STAFF RECOMMENDATION 1103 Montrose Avenue April 19, 2017

Application: New construction—addition and outbuilding; Setback determination
District: Waverly-Belmont Neighborhood Conservation Zoning Overlay
Council District: 07
Map and Parcel Number: 11801013400
Applicant: Steve Durden, Durden Architecture
Project Lead: Melissa Baldock, melissa.baldock@nashville.gov

Description of Project: Application is to construct a rear addition and an outbuilding. The addition requires a side setback determination, and the outbuilding requires both a side and a rear setback determination. The outbuilding will not be used as a detached accessory dwelling unit.

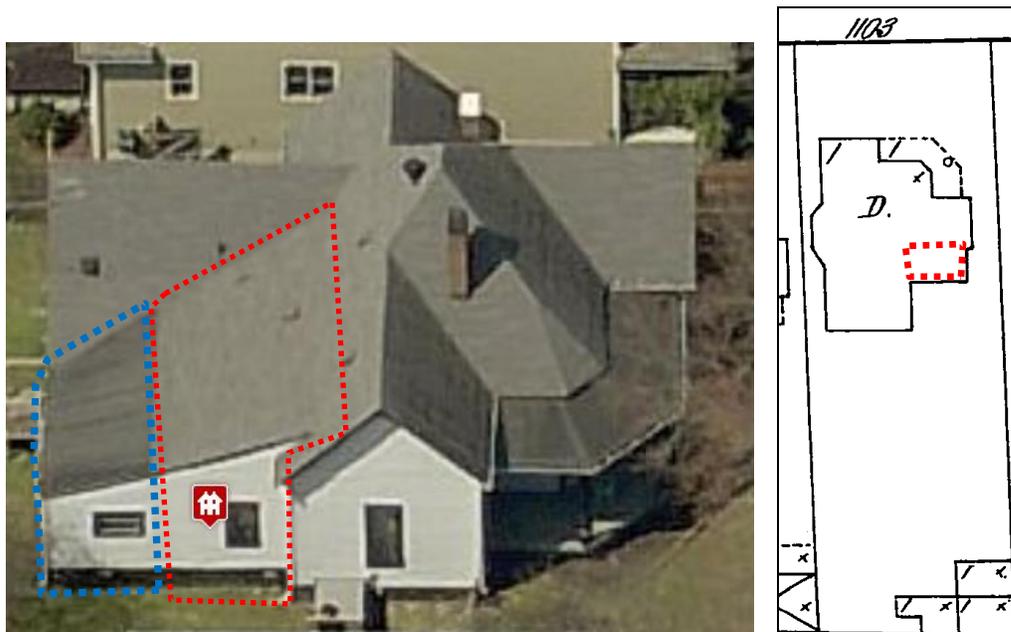
Partial Demolition: The applicant intends to demolish a portion of the rear of the existing house. On the left elevation, the applicant intends to demolish and reconstruct the shed roof portion of the house, behind the side-gabled bay (Figure 2). Part of this area is historic and likely part of the original house, as it appears in the 1914 Sanborn Map (Figure 3). The original part of the house is marked in red in Figures 2 & 3 below. The area marked in blue in Figure 2 does not appear in the 1914 and the 1957 Sanborn maps. Staff finds the demolition and reconstruction of this portion of the house with a new roof form to be appropriate because it not a significant portion of the house’s principal pyramidal roof form and because it is not highly visible from the street (Figure 4). The pre-1914 portion of the roof has a utilitarian look and could have formerly been an enclosed porch.

Figure 2 (Top left) shows the area of the house to be demolished and reconstructed. The red area is likely original to the house and the blue portion dates to post 1957. Figure 3(top right) is the 1914 Sanborn Map, showing the red area that will be demolished. Figure 4 (Bottom left) shows that the portion of the house that will be demolished will not be highly visible from the street, as it is behind a bay.

Figures 5 & 6 Show the area of the right, rear that will be demolished.

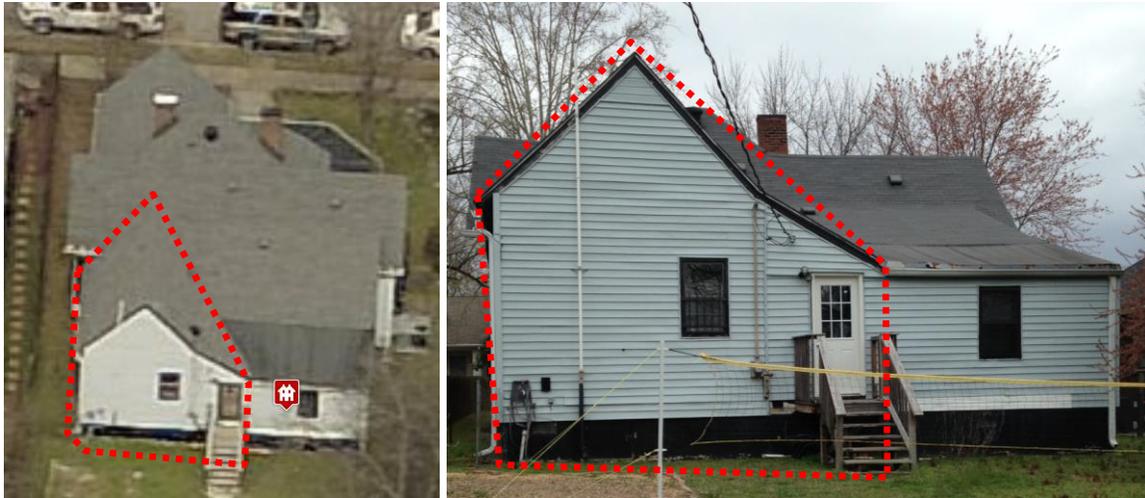
On the right elevation, the applicant intends to demolish the rear gable area (Figures 5 & 6). This area is original to the house. However, this portion of the house has significant foundation and structural issues. The applicant intends to demolish this portion of the house and reconstruct it with the same dimensions. Because of the structural issues with this part of the house, because the area will be reconstructed in the same dimensions and because this portion is not significant to the main massing of the historic form, staff finds this demolition to be appropriate.

Staff finds that the proposed demolition meets Section V.B.2 for appropriate demolition and does not meet section V.B.1 for inappropriate demolition.

Architectural Site Plan
 Scale: 1/16" = 1'-0"

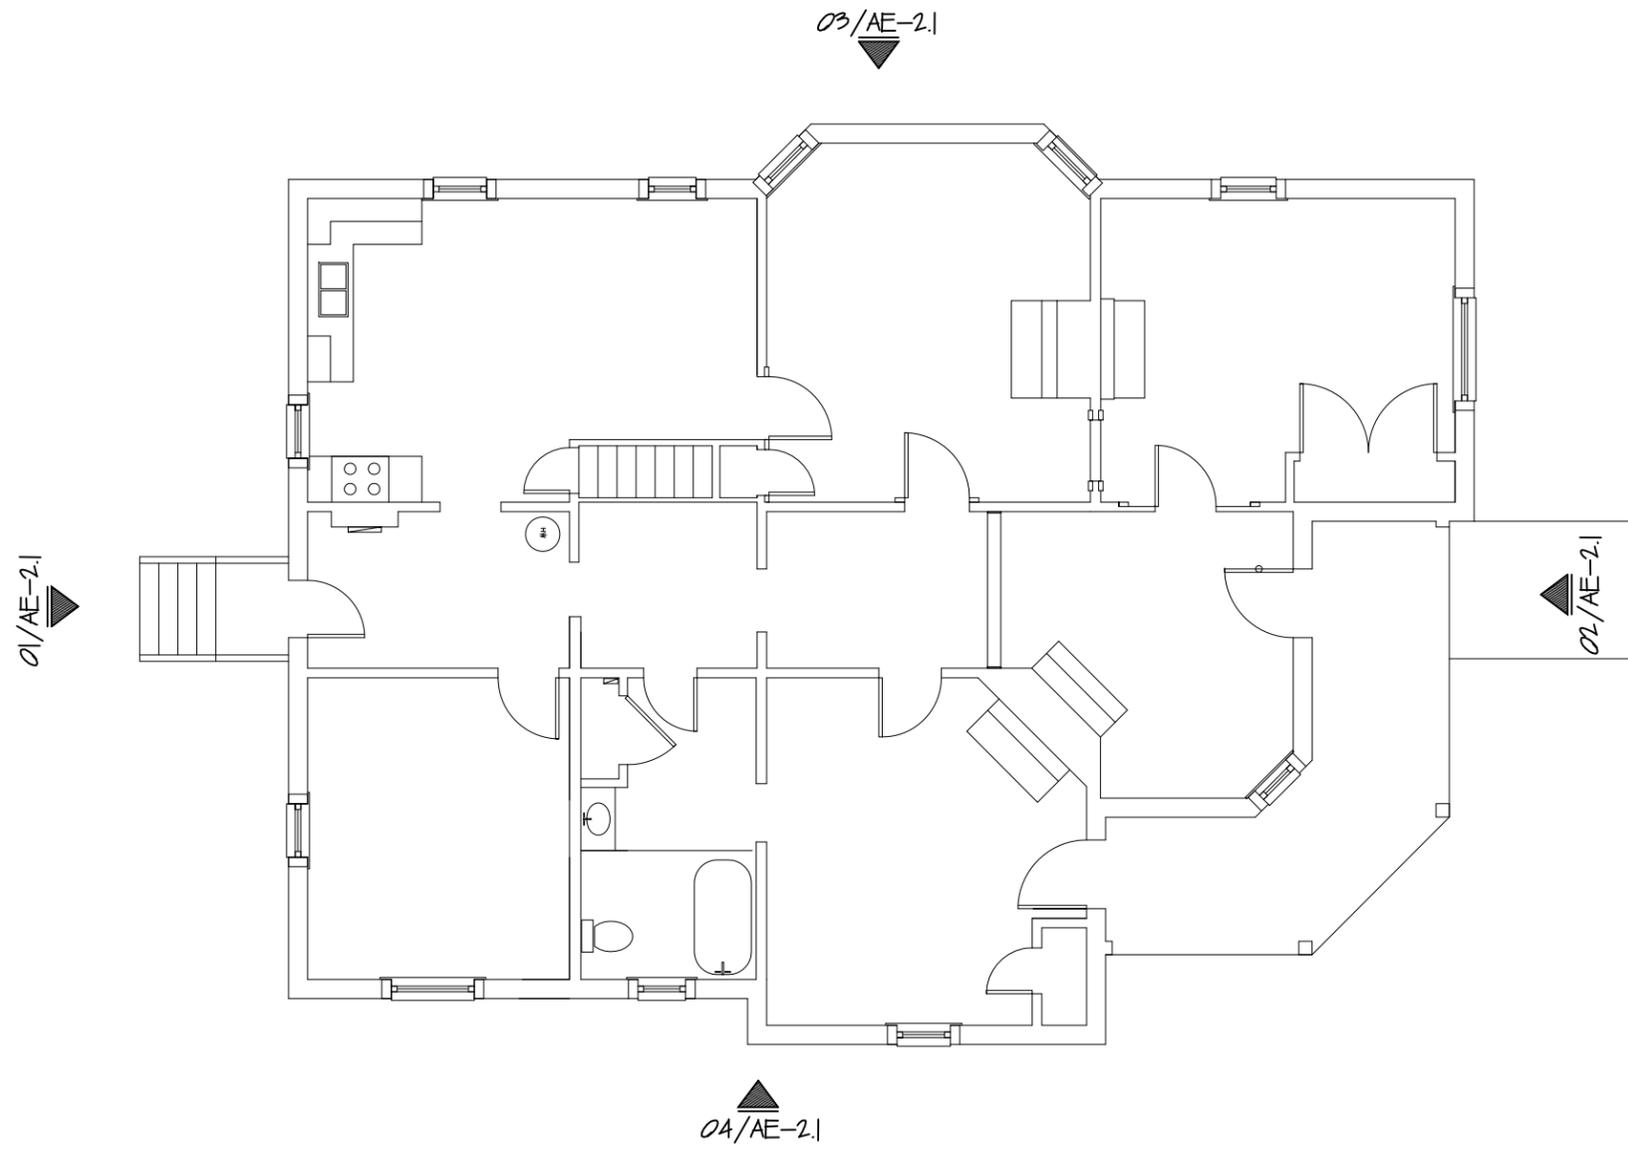
Setback & Rhythm of Spacing: The addition will be approximately six feet, six inches (6’6”) from the left side property line and will be approximately sixty feet (60’) from the rear property line. Both of these meet the base zoning setbacks and are appropriate. On the right side, the addition will not meet the five foot (5’) base zoning setback. The addition will be just three feet, nine inches (3’9”) from the side property line. Staff finds the proposed side setback to be appropriate because the addition will not be any wider than the historic house; a portion of the historic house is located just three feet, four inches (3’4”) from the side property line. Also, the portion of the addition that is less than five feet (5’) from the side property line is just fifteen feet, eight inches (15’8”) deep.

The proposed outbuilding requires a rear and side setback determination. Base zoning requires a twenty foot (20') rear setback when an outbuilding's footprint is more than seven hundred and fifty square feet (750 sq. ft.). The applicant, however, is proposing to situate the outbuilding just nine feet, one inch (9'1") from the rear property line.

Staff finds that the proposed nine feet, one inch (9'1") rear setback to be appropriate because historically, outbuildings were situated close to the rear property lines. A nine feet, one inch (9'1") rear setback is more historically appropriate than a twenty foot (20') rear setback. The reduced rear setback allows for more space in between the house and the outbuilding, which is appropriate. In addition, because the rear property line abuts an alley, the reduced rear setback will not directly affect any adjoining properties.

Similarly, base zoning requires a five foot (5') side setback when an outbuilding has a footprint greater than seven hundred square feet (700 sq. ft.). The applicant is proposing a three foot (3') side setback on the left side. Staff finds the proposed side setback to be appropriate because historically, outbuildings were located close to side property lines. In addition, if the outbuilding were to be just fifty square feet (50 sq.ft.) less in footprint, the base zoning setback would be three feet (3'), as is proposed.
